TECHNICAL BULLETIN

Intermittent Power Loss – Tach Drops to Zero – Reposition Ignition Amplifier – Service Action S 439

18-41

MODEL XJS V12 Range 1994 MY

ILLUSTRATION 1

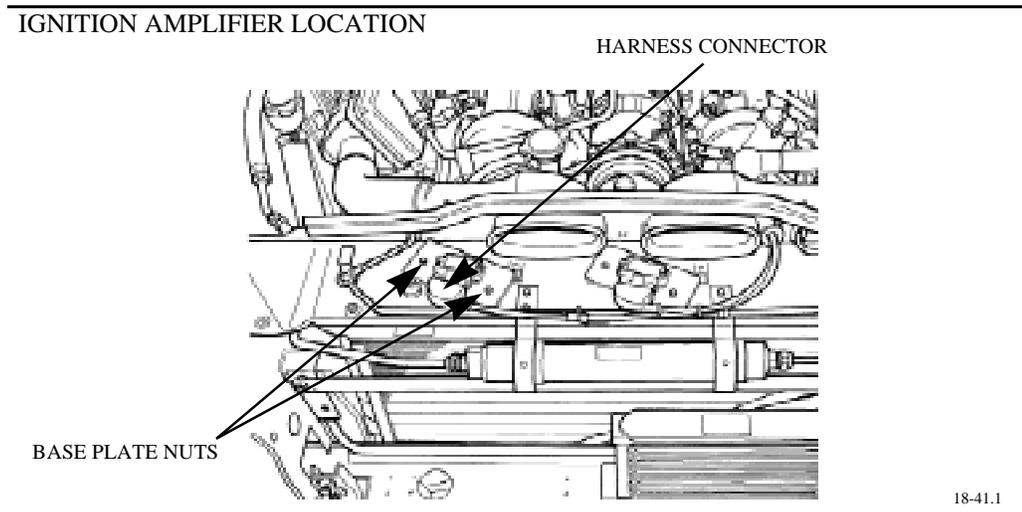
Symptoms of intermittent power loss or engine misfire, with the tachometer needle dropping to zero, may be caused by the under hood liner coming into contact with the “A” bank (right) ignition amplifier connector housing. This may cause damage to the right side primary catalytic converter. To prevent this contact from occurring, the ignition amplifier was repositioned at VIN 194707.

1. Disconnect the “A” bank (right) ignition amplifier harness connector and remove the two amplifier base plate nuts (Illustration 1).

ILLUSTRATION 2

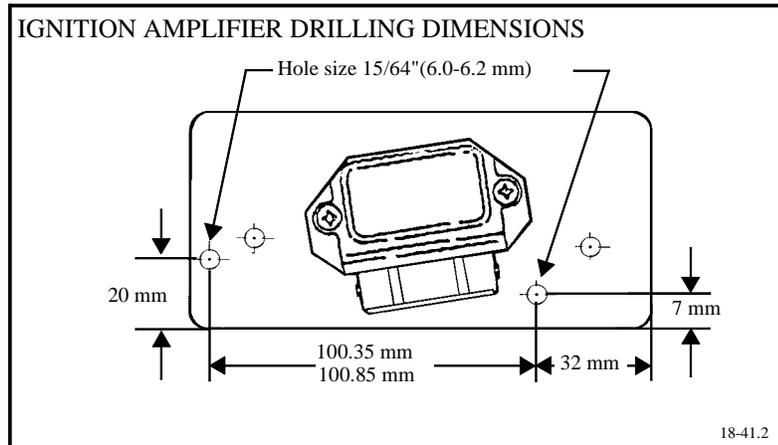
- On the amplifier base plate, mark the position of the two new holes. Drill two 15/64" (6 mm) holes as shown in Illustration 2.

- Deburr the drilled holes. Use compressed air to clean drill chips from the amplifier and base plate.
- Remove the masking tape and inspect the inside of the connector housing to be sure it is clean.
- Reinstall the amplifier assembly using the new mounting holes.
